ADDENDUM NO: 001

PROJECT NAME: Ransom Canyon Jones-Warner Park
Improvements

PROJECT NO.: 41339.23

This Addendum consists of one page and the attached drawing(s) no(s). Sheet ES100 ELECTRICAL SITE PLAN and E-601 ELECTRICAL SCHEDULES.

Electrical Schedules
E-601

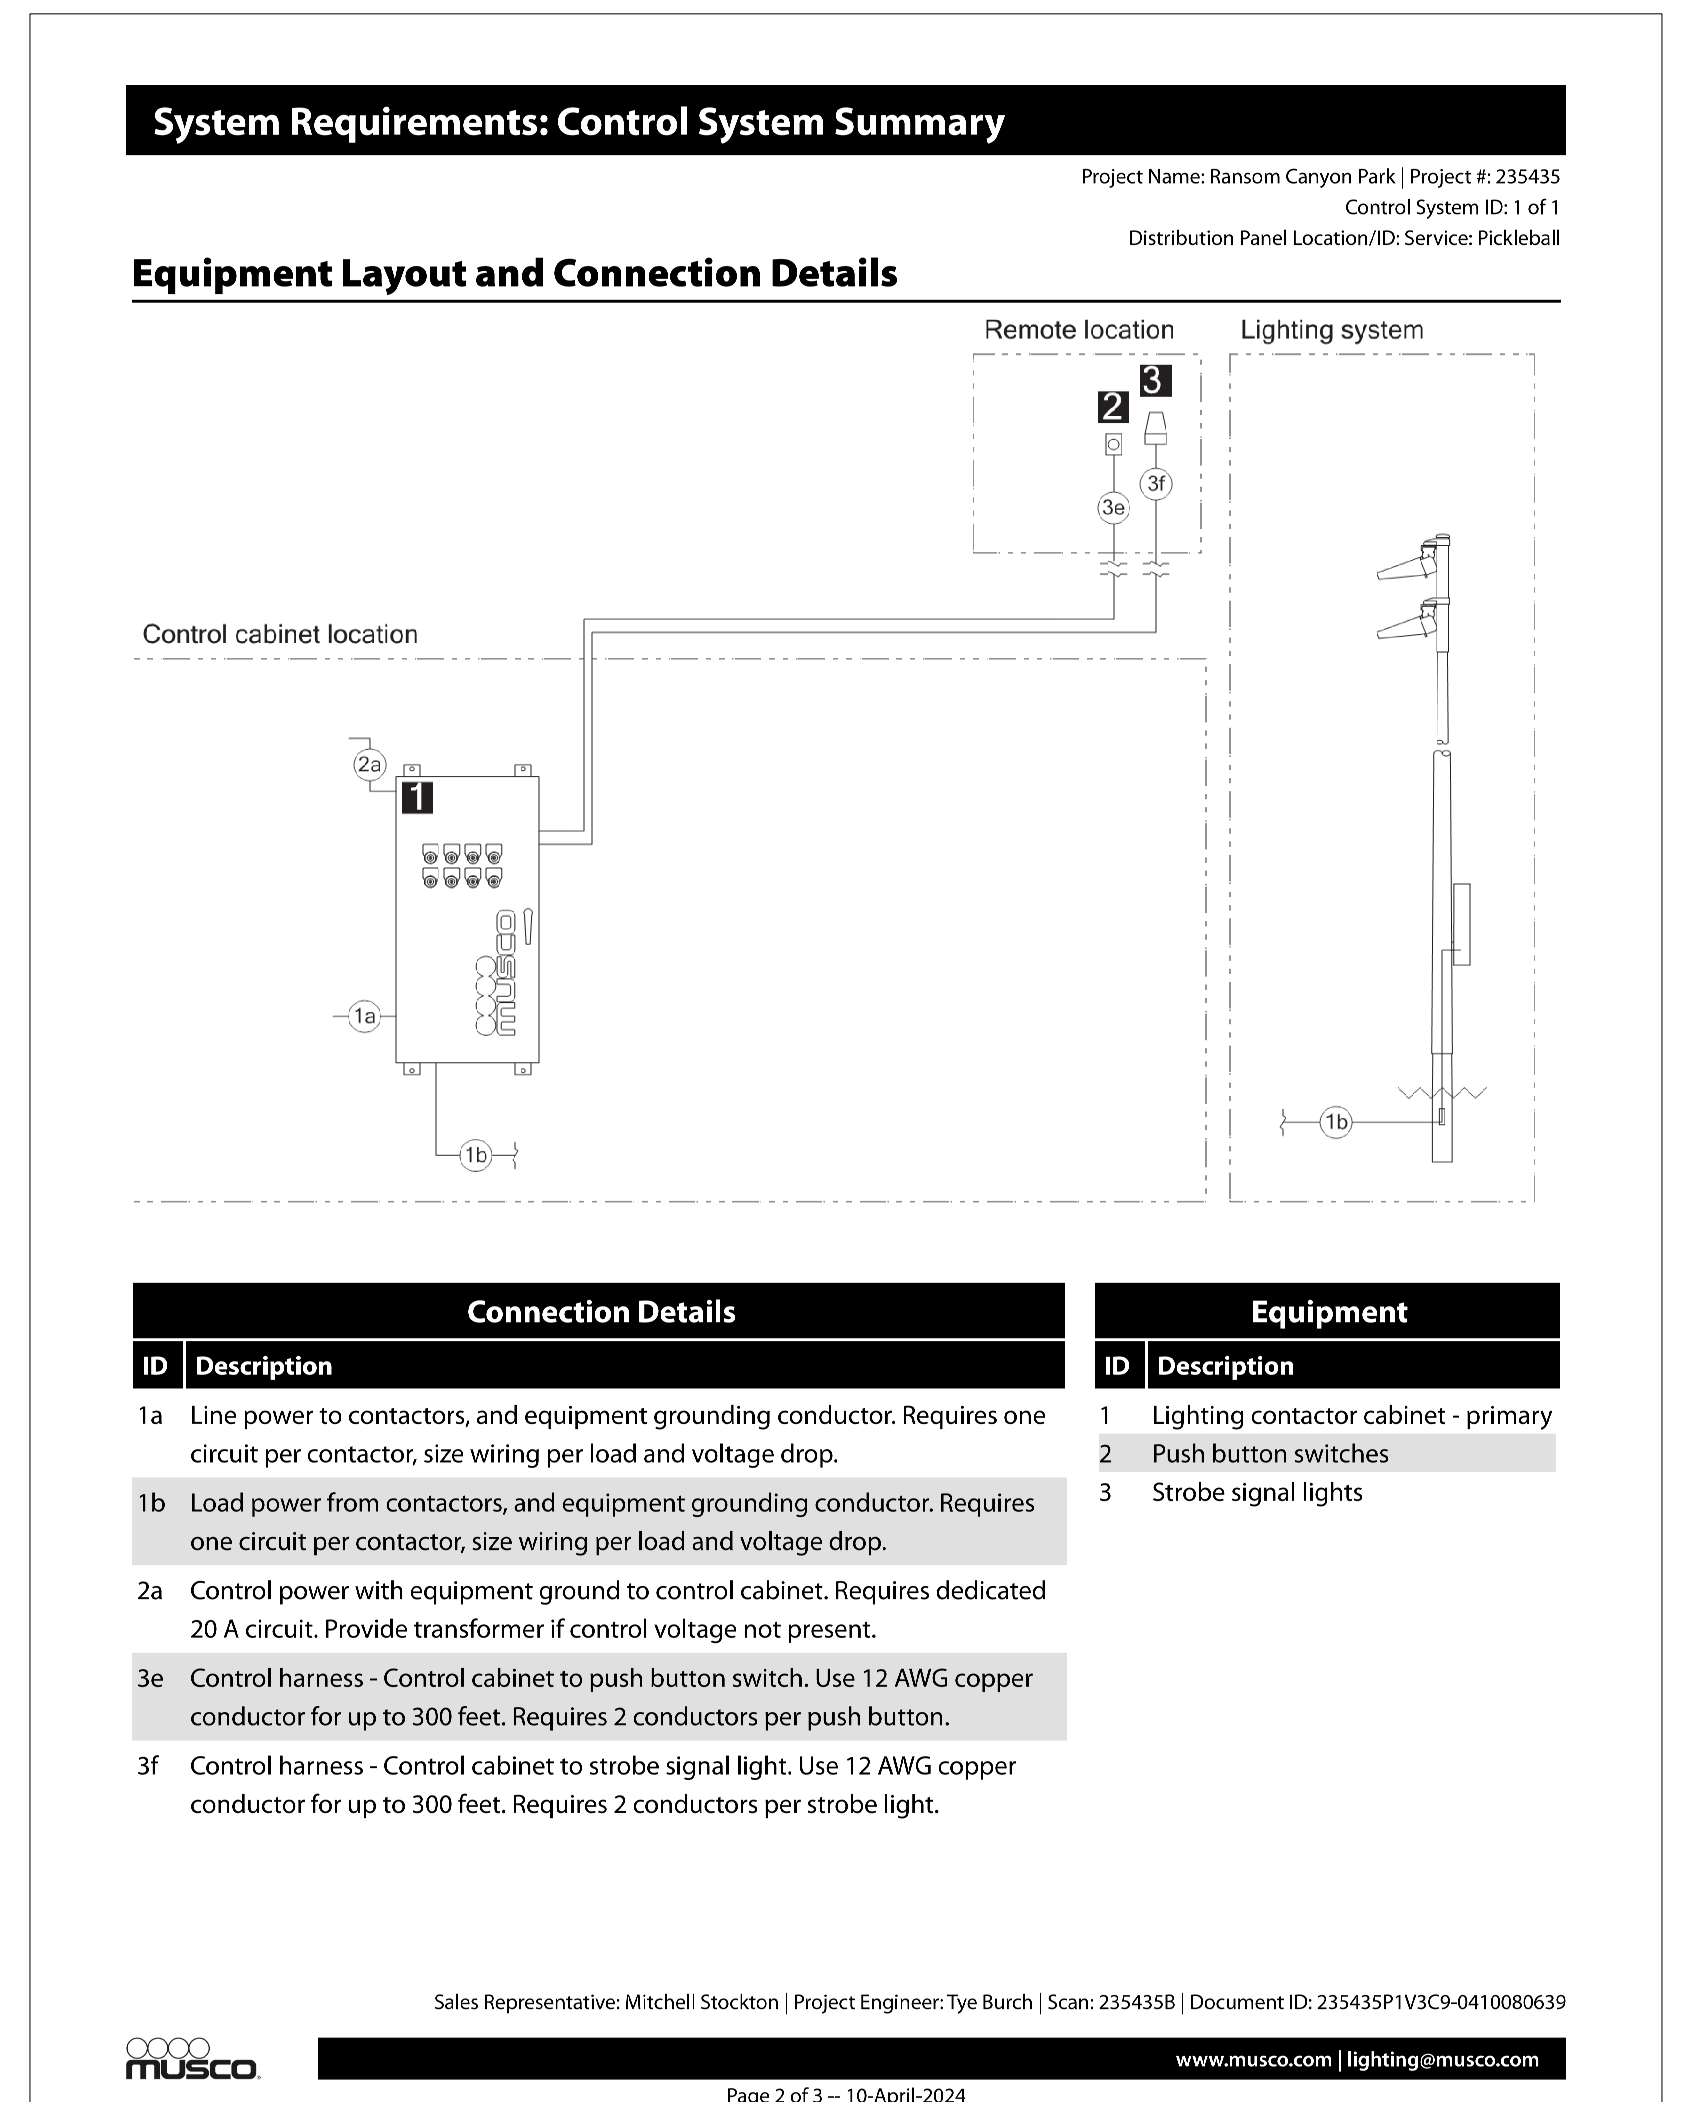
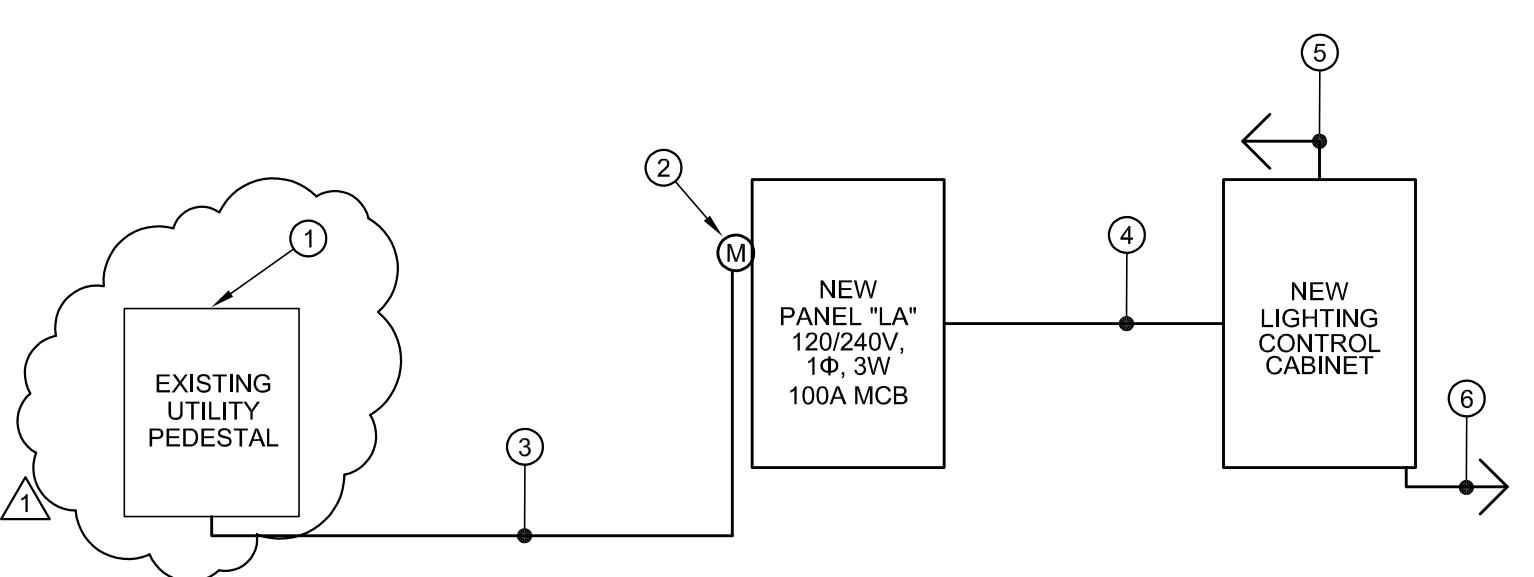
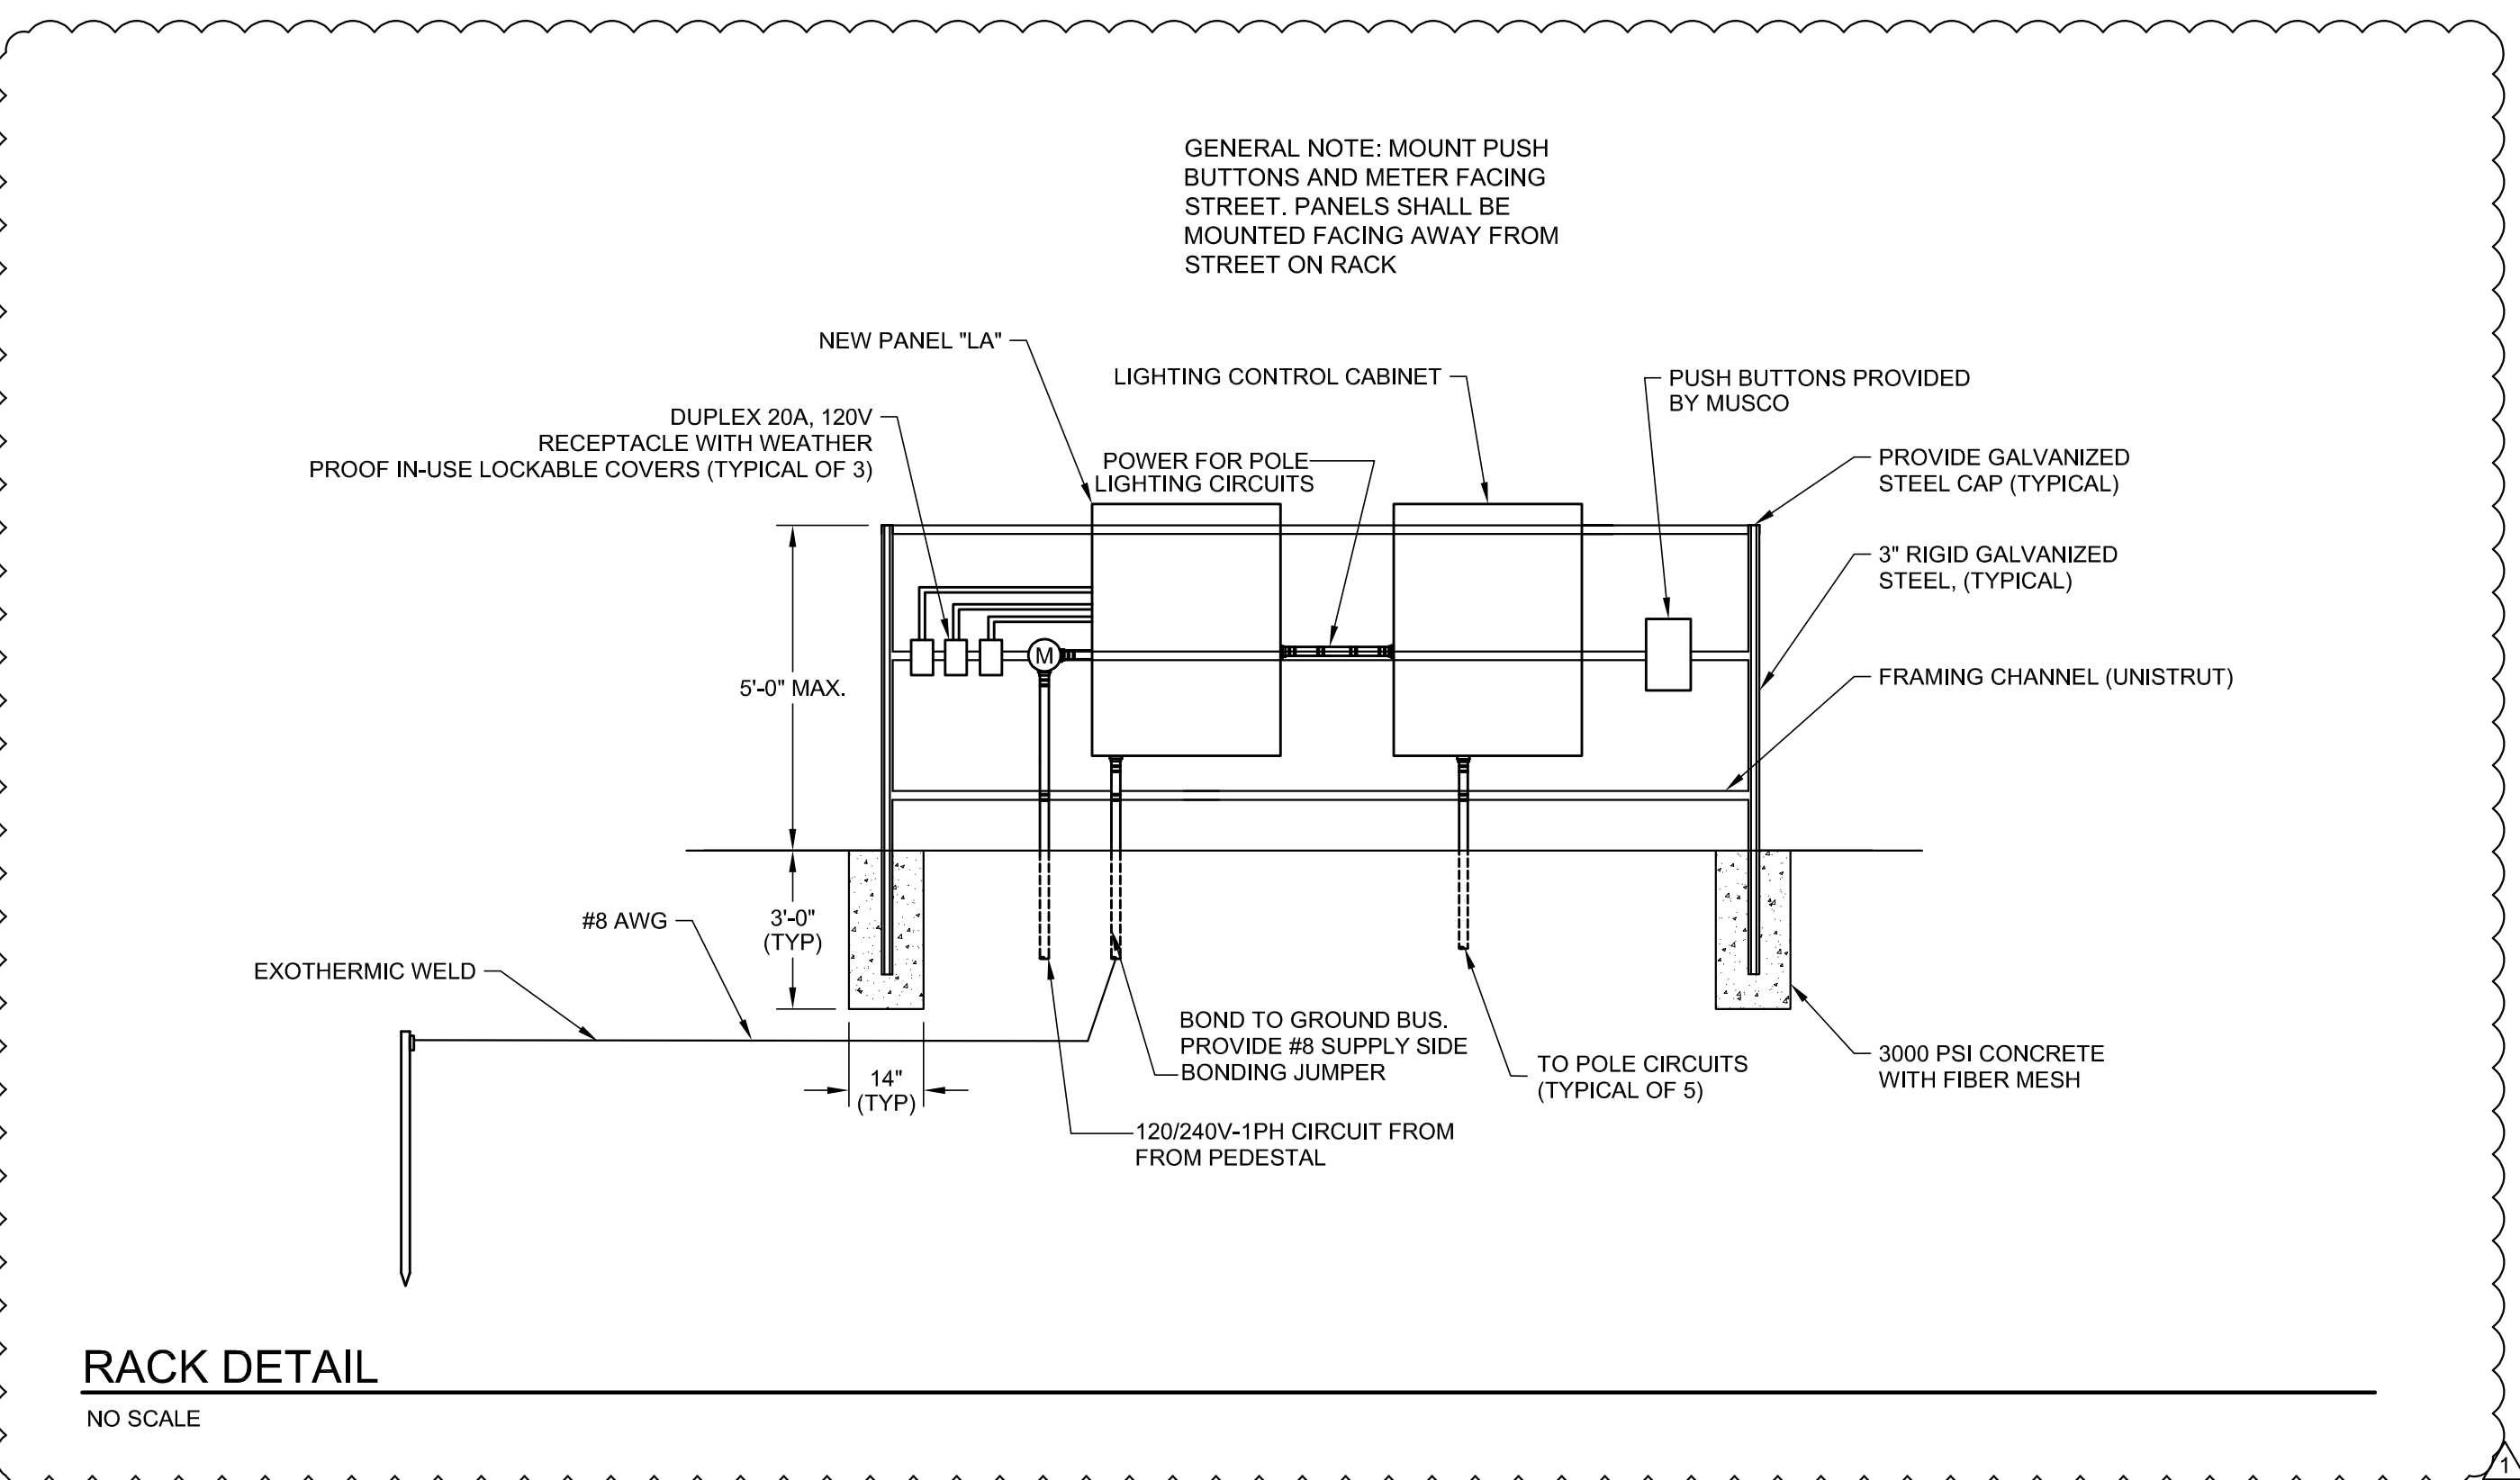
1. SHEET ES100 – ELECTRICAL SITE PLAN
 - a. Relocated electrical service, panel LA, and sports lighting control panel to new location. Refer to sheet for new location.
 - b. Keynotes 1 and 2 have been updated.
 - c. Existing lights that shall be removed have been shown on sheet. Refer to sheet for location and additional information.
2. SHEET E-601 – ELECTRICAL SCHEDULES
 - a. Electrical Riser Diagram has been updated. Refer to sheet for additional information.
 - b. Keynotes 1, 2, and 3 have been updated.
 - c. Rack detail has been updated.
